October 29, 2020

Re: Site Plan Review; Special Permit for Parking, and Downtown Overlay
District Special Permit - Revised Plans
93 State Street, Newburyport, MA (the "Property");
Assessor's Map: 14 Lots: 39 and 40

PERMIT SITE DEVELOPMENT PLANS
 (TO ACCOMPANY A SITE PLAN REVIEW APPLICATION)

**Institution for Savings
Office Addition**

2 Prospect St Elevation
1/8" = 1'-0"

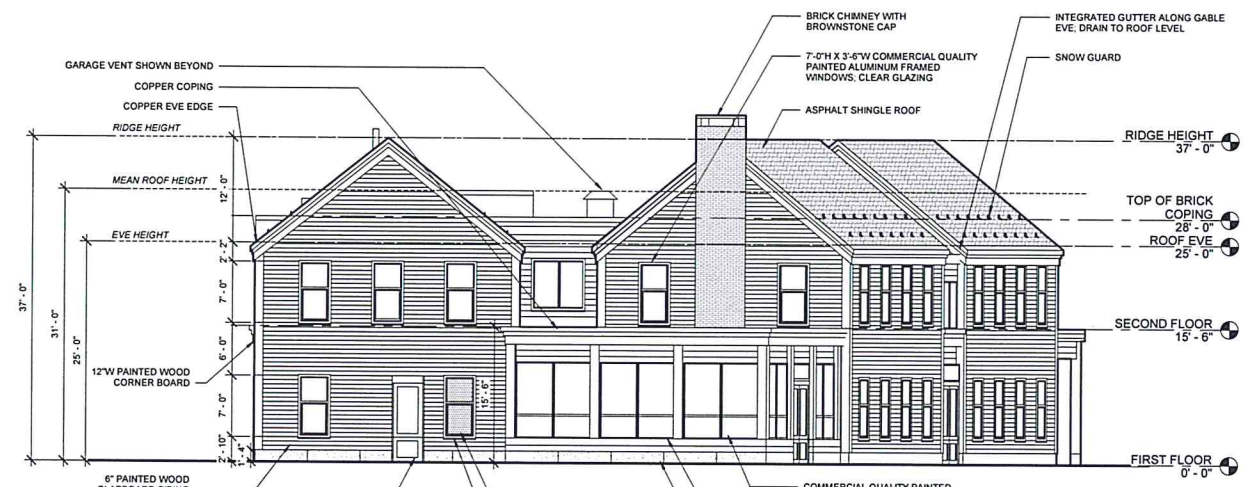
- Eave Height³: The Board and the Historic Commission requested the Bank lower the eave height along Prospect: the eave height of the proposed sections of the new building along Prospect is 25'. The residential structures along Prospect from 11-21 have an eave height of 23' 9". The eave height of the entry way to the Bank along Prospect is 15' 6", the home at 9 Prospect directly across the street is at 16' 6" with an eave height of 9' 2".

- Length of façade: The length of the two delineated facades of the proposed structure along Prospect are 36' 7" each. The length of the facades of the 11-13, 15-17 and 19-21 structures are: 42' 8", 42' 6" and 41' 10" respectively. The length of the façade of the delineated gable end section of the building along Otis is 28' 8". The length of the facades along Otis at 16 Prospect, 3 Otis and 9 Otis are 40', 30' and 46' respectively.

Illustration 1: Section looking East down Prospect St.

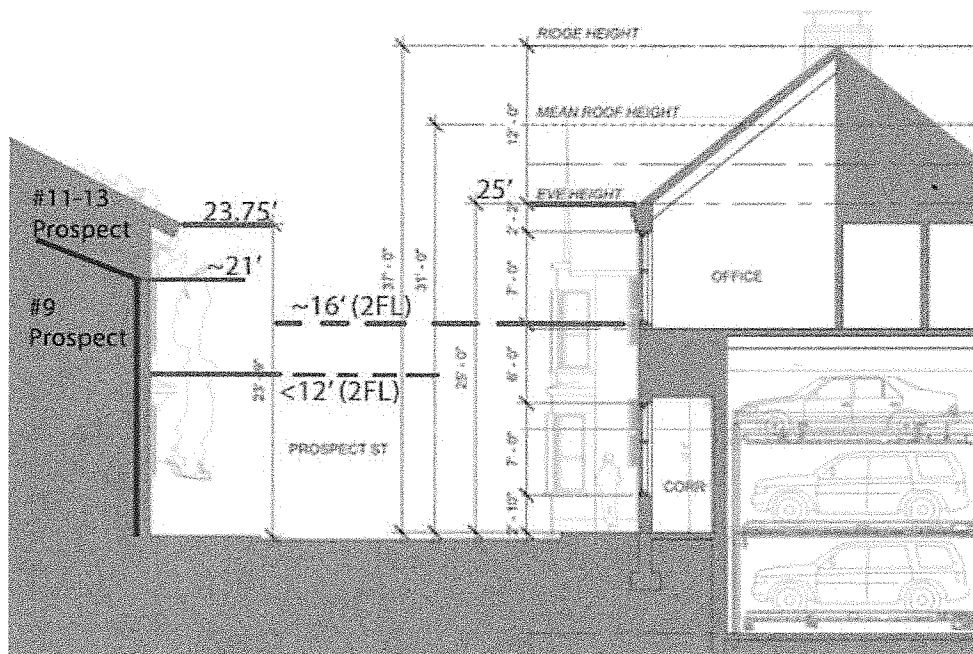
While the latest plans reflect an exemplary effort to make the architectural design of the proposed building fit more harmoniously within its setting, they do not resolve the single biggest issue: massing, or to use a more commonly understood term, "size." It is clear that parking requirements are a key aspect of the "program," but the parking system chosen requires a first floor height of about sixteen feet, which forces the rest of the building higher than normal. When you understand this, you easily understand why the universal sentiment expressed by neighbors is "It's too big."

The following image is a “section” taken along Prospect Street from the applicant’s presentation. Colored lines have been added to aid a comparison of height between the proposed structure and neighboring structures across the street. I have also added the (approximate) eave height for 9 Prospect St., which is an older and smaller house, and comparison lines at the approximate height of the second floor:

NB: The provided renderings of this view from the 3D model are of limited value because they are oblique views, which make direct height comparisons difficult. The Planning Board may find it helpful to get renderings from the model of this, and similar views, that are straight-on, to avoid distortion caused by horizontal perspective, where nearer objects appear relatively larger than they normally would.

Perhaps these images are better than words to show that the proposed structure is too massive – especially too high – to fit harmoniously into its locale.
